Response to Referee #1 (Alek Petty)

Review of “Year-Round High-Resolution Sea Ice Freeboard Retrieval Using ICESat-2 ATL03 Photon Data” by Liu et al.,

Fig R2 Comparison between HRFM within-segment height STD and ATL07 Gaussian width.

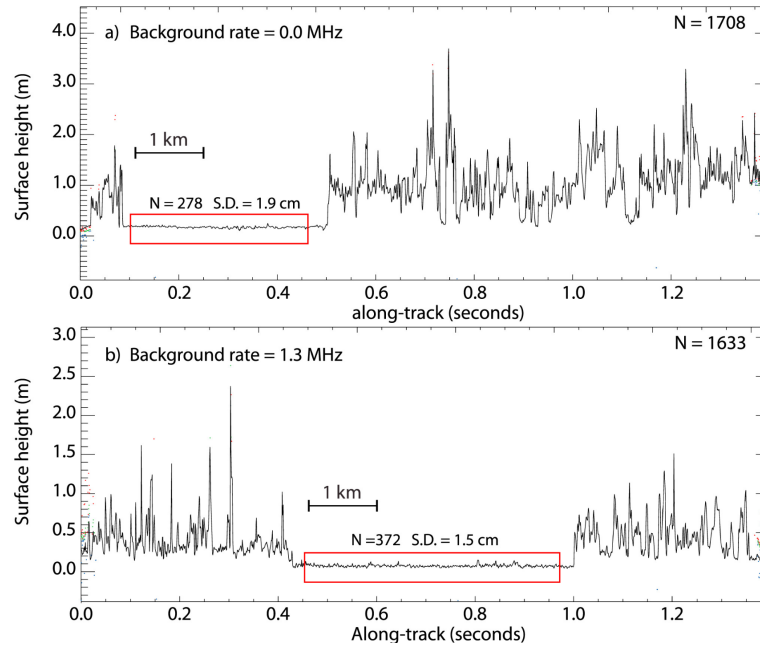
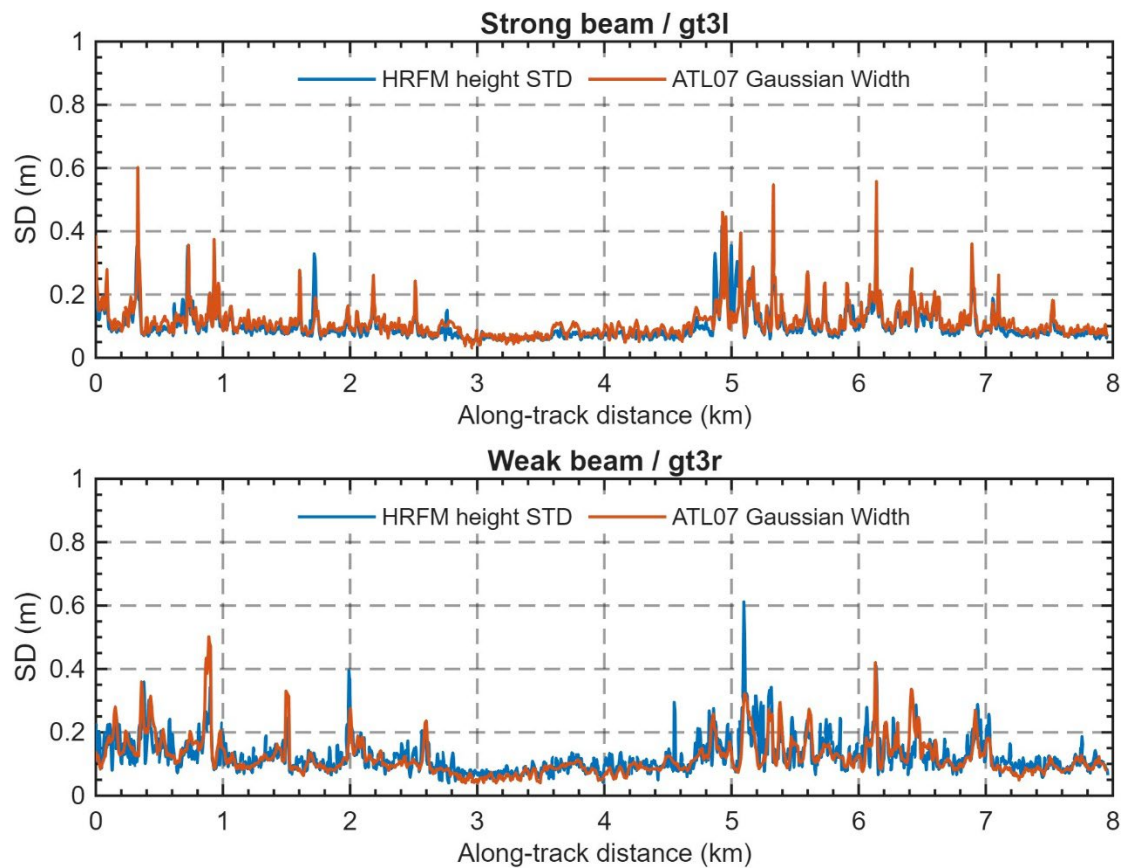
We can see by your height SD plots that your use of a much finer fixed 5 m along-track photon aggregation is resulting in roughly 10 cm height standard deviations over open water leads, which is quite high! This all needs to be discussed way more in terms of impacts on freeboards.

As defined in Kwok et al., (2019), **precision** refers to the repeatability of height measurements over a given spatial scale, typically assessed as the standard deviation of height estimates over flat surfaces at kilometer scales (e.g., 3–10 km). In that study, precisions of 1.5–1.9 cm were obtained by aggregating some segments (Fig R1). As shown in Fig.8 of the original manuscript, our method achieves comparable centimeter-level precision when evaluated over kilometer-scale flat leads as well. In contrast, the standard deviations shown in Fig. 4 of the original manuscript represents the within-segment photon height variability. This metric is different from the ATL07 precision definition used in Kwok et al., (2019) and is instead analogous to the Gaussian width parameter reported in ATL07. This is supported by the strong consistency between the HRFM within-segment height standard deviation (STD) and the ATL07 Gaussian width parameter, as shown in Fig. R2.

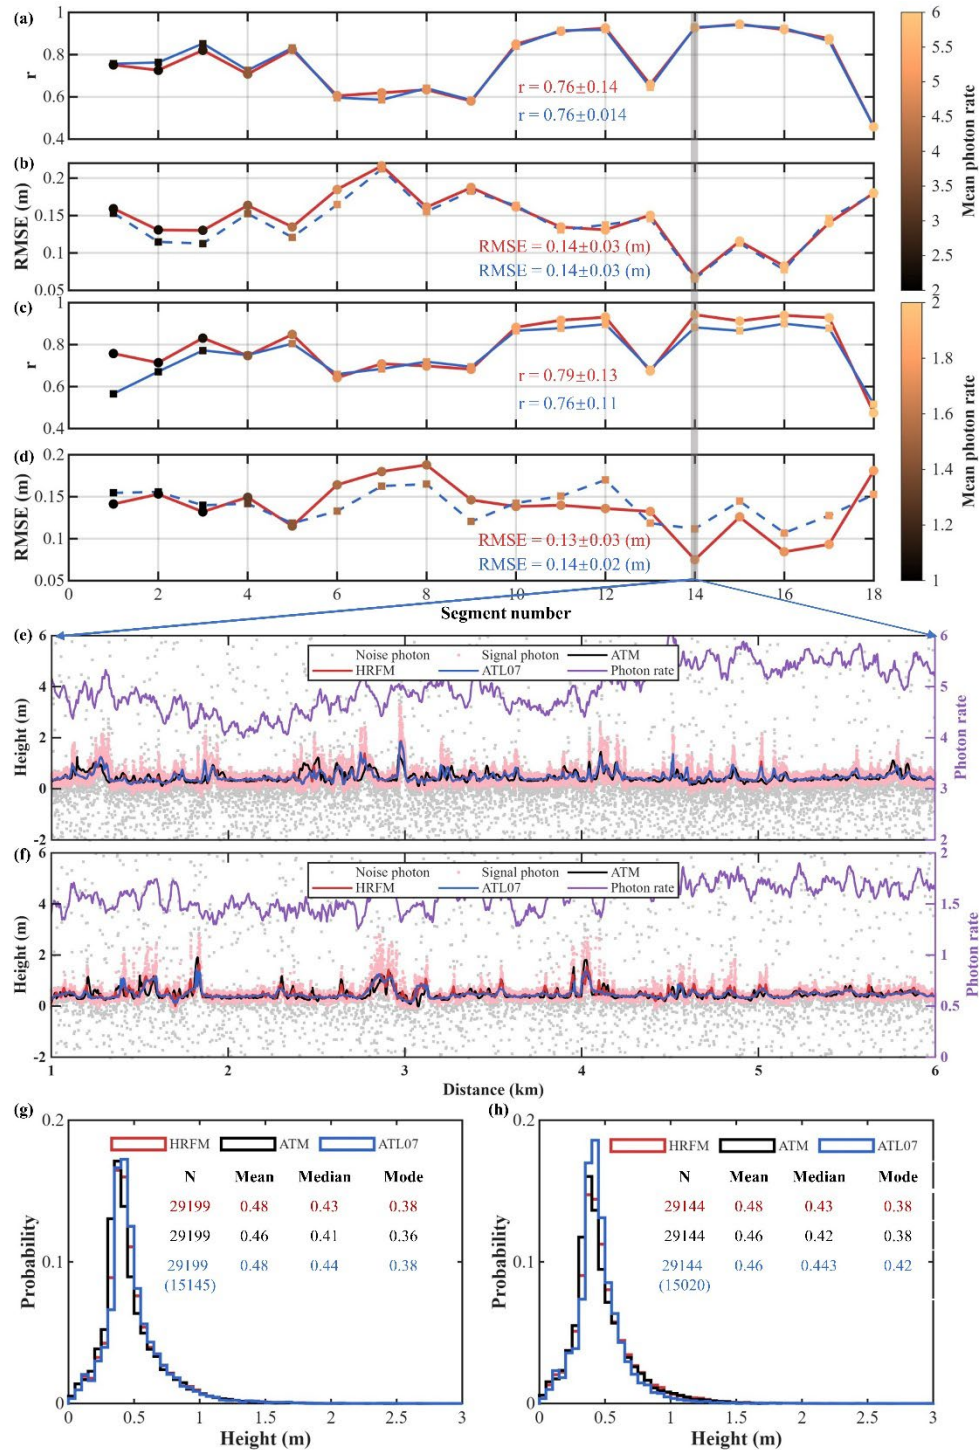
The ATM comparison section needs more clarity. For one, it is not clear whether you implemented the cross-correlation maximization procedure used in Kwok (2019). In that study, raw ATM was aggregated into 17 m by (segment length plus 17 m) blocks with Gaussian weighting, and the ATM data were shifted to maximize correlation with ICESat 2. What exactly have you done here? Are you using the same aggregation? Are you shifting the profiles? Which beams are included in the comparisons? Note that the current thinking is ~11 m footprints (Magruder et al., 2020), but maybe 17 m would keep things consistent with Kwok.

Your reported correlations and RMSE values between ATM and ATL07 are notably worse than the very high values reported in Kwok (2019). The lack of details regarding the processing and comparison approach needs a lot more explaining to make such a big claim (unless I am missing something!). It would also be helpful to repeat the April 8 and 12 flights shown in Figure 1 of Kwok (2019) as a sanity check. At the moment it is difficult to reconcile and trust the differences presented.

Following the referee's suggestion, we re-examined the ATM underflights acquired on 8, 12, 19, and 22 April 2019. In the revised manuscript, the 22 April case is used as the main validation example because it provides the clearest overlap with both the strong

and weak ICESat-2 beams. The 8 April and 12 April (Fig R3) flights are now included as additional sanity checks in the Appendix. These additional comparisons confirm that the validation statistics are sensitive to the degree of ATM–ICESat-2 spatial overlap and to the use of non-shifted collocation. In particular, the 12 April case shows degraded statistics for both HRFM and ATL07 under poorer overlap. The 19 April underflight was also examined, but it was not used for quantitative statistics because the spatial overlap with the corresponding ICESat-2 ground track was insufficient for a reliable segment-wise comparison.

Fig R4 Performance of HRFM photon filtering under cloudy conditions.

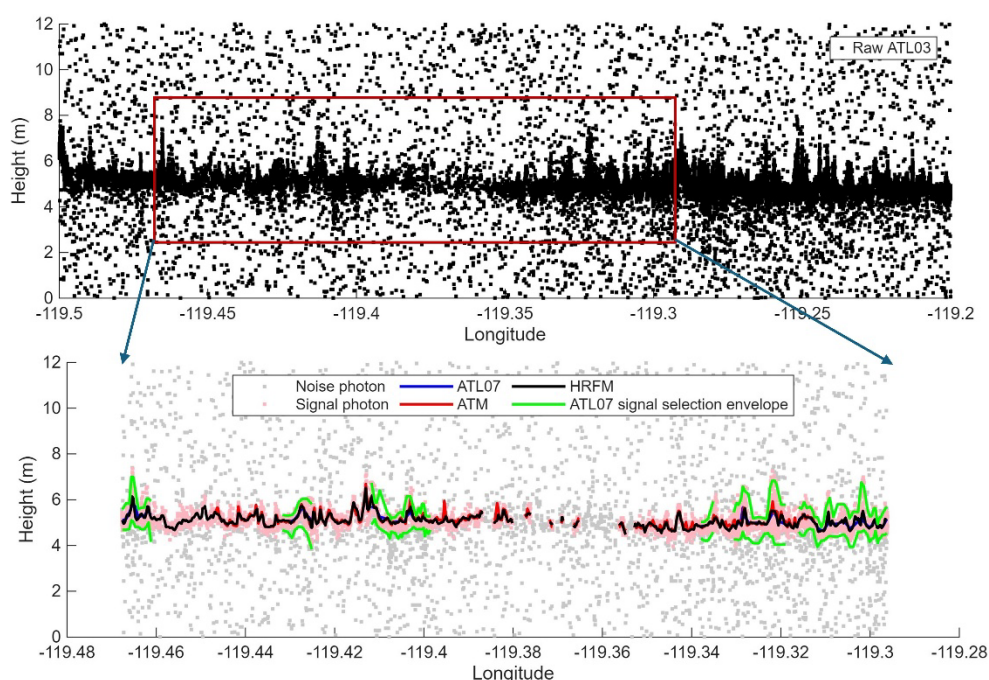
The photon filtering strategy needs more explanation. ATL07 uses windowing filters to separate signal from background photons, I was surprised you do not do any windowing. I wondered what would happen in cloudy conditions with your approach as I don't think you are implementing any type of cloud filter. The coarse filtering does not appear to work very consistently, but the second step does. I am a bit worried you're showing the best cases here, which is why I would like to see the along-track data included with the release (see comment later).

We will clarify this point in the revised manuscript. Although the original text did not emphasize it, HRFM includes a window-based constraint during the coarse denoising stage. Specifically, after the initial density-based coarse signal extraction, candidate signal photons are further checked against a local height window defined from the modal height in the 3 km along-track window. Candidate photons are retained only within the range from 2 m below to 6 m above the modal height. This step is designed to retain ridge returns while reducing the risk of selecting erroneous returns under cloud-attenuated or noisy conditions.

Fig R4 shows a cloudy-condition example from 22 April 2019, where the raw ATL03 photons do not show a clear surface return because of cloud-related signal attenuation. HRFM still identifies the residual surface signal, and the retrieved height remains broadly consistent with the ATM profile. The release of along-track data is discussed in the Data availability response below.

Fig R5 Monthly freeboard distributions derived from strong and weak beams using HRFM.

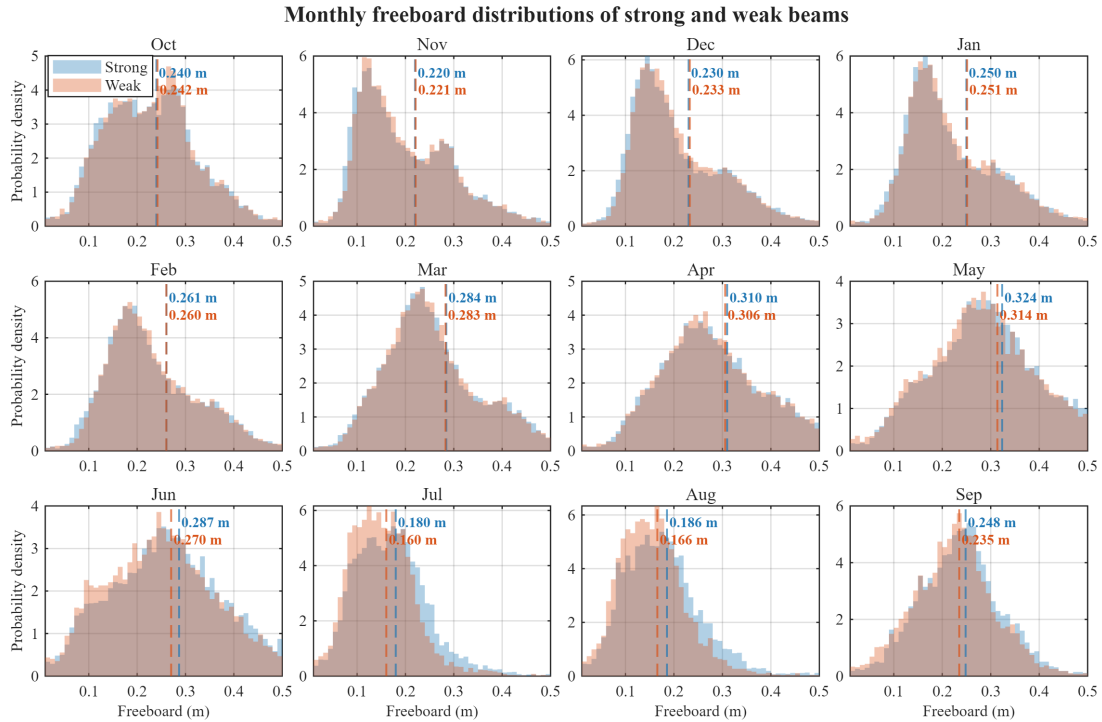
ATL07 reduces the energy of the middle beam by a factor of 0.82. Is this applied here? You report 2 to 3 cm freeboard differences between strong and weak beams. I would not call that slight. It would be clearer to show this as a difference plot rather than as two separate seasonal curves.

We agree that a 2–3 cm strong–weak beam freeboard difference should not be described as “slight”. We will revise this wording and discuss the remaining inter-beam difference more cautiously. To make the comparison clearer, we provide an additional diagnostic in Fig R5, which shows the monthly freeboard distributions for strong and weak beams under the same HRFM processing framework. The strong- and weak-beam distributions largely overlap in most months, indicating broadly consistent retrieval behavior, although small centimeter-scale differences remain.

Fig R6 Corrected plot of Fig. 9c

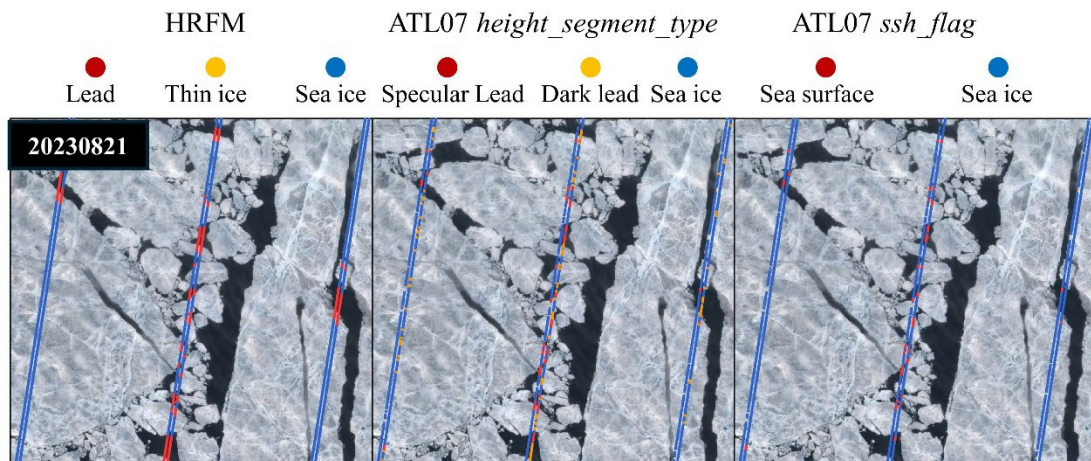
I include in major comments as I find this quite confusing/worrying (?). But in the middle profile for the bottom lead, *height_segment_type* shows sea ice while *ssh_flag* is set to sea surface on one of the beams (see yellow circles). How is that possible?

We checked Fig. 9c carefully and found that the issue was caused by a plotting error. The ATL07 classification in this case contains a -1 value, corresponding to an invalid

segment. This category had not appeared in the other examples, and the original plotting code did not explicitly handle it. As a result, the -1 category was assigned to the first color in the colormap, which shifted the color mapping of the remaining ATL07 classes. We have corrected the plotting code by explicitly assigning colors to all ATL07 class values, including the -1 invalid category. The corrected version of Fig. 9c is shown in Fig R6. We will revise the text related to the figure.

Figure 1 The flowchart of HRFM

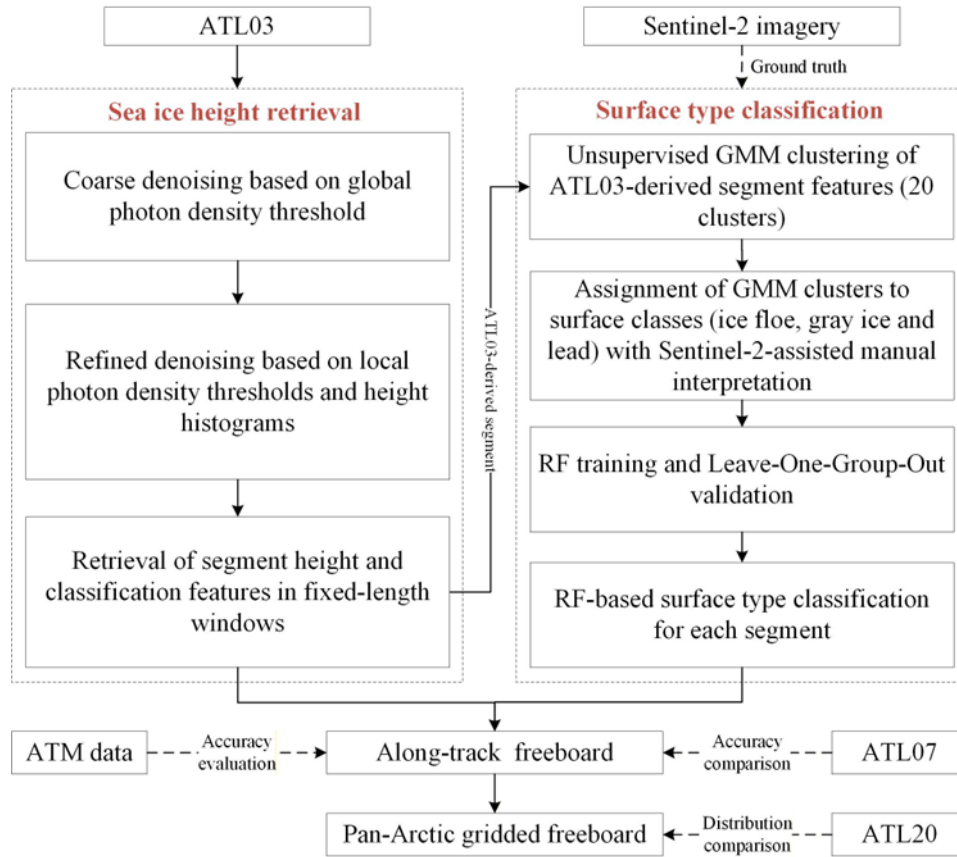
Figure 2: As I understand the workflow, the authors first grouped HRFM segments into 20 GMM clusters and then manually assigned these clusters to three surface classes using Sentinel-2 imagery. However, this important step is not easy to follow from Fig. 2. I suggest revising the flowchart so that the intermediate GMM clustering step and the subsequent human interpretation/manual class assignment based on Sentinel-2 imagery are shown more explicitly. This would make the training-data generation procedure clearer to readers.

Figure 2: Please show the RF classifier more explicitly in the workflow after the GMM clustering and manual labeling steps.

We will make the training-data generation workflow clearer, as Figure 1 shown.
